Thank you for your letter dated the 16th October advising me of the retrospective planning permission that has been requested by my neighbours at 5A Weir Street. Please see below my comments which I hope you will take into account in making a decision inline with your outlined material considerations:

Directorate of Communities # Environment, city Hall, Beaumont Fee, Lincoln LNI IDF Your Reference: 2018/1004/HOU

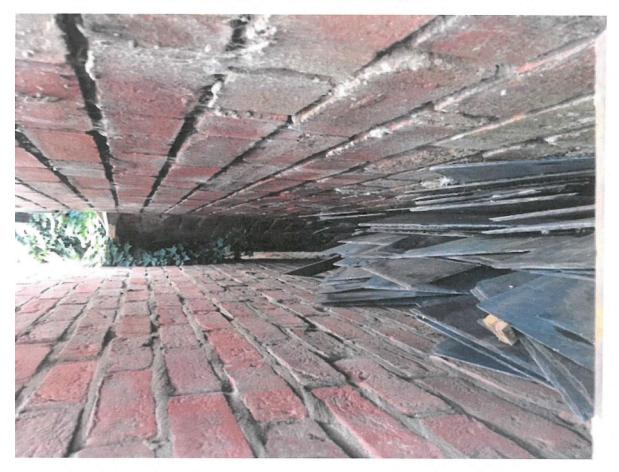
6) Rainwater is discharged directly into the rear alleyway in the hope that it will eventually find it's

way to an old gulley metres away. Consequently the alley floods and water is drawn up the face of my walls where it enters the inside and leaves algae growth.

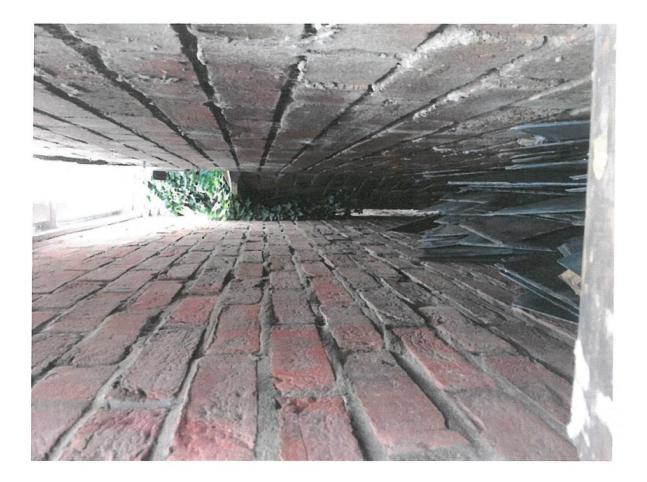
7) Rainwater pipes extend into the alleyway reducing the width available to negotiate with rubbish bins and accessing goods in and out via the rear of my property.I will send relevant photographs supporting my objections.

Please see photo of alleyway behind my property. On one occasion I had to put my wellington boots on to take my bins out. I did ask the tenant if he could put a soak away in when he built the outbuilding, instead he put the guttering in the alleyway which is causing considerable damage to my outbuilding.
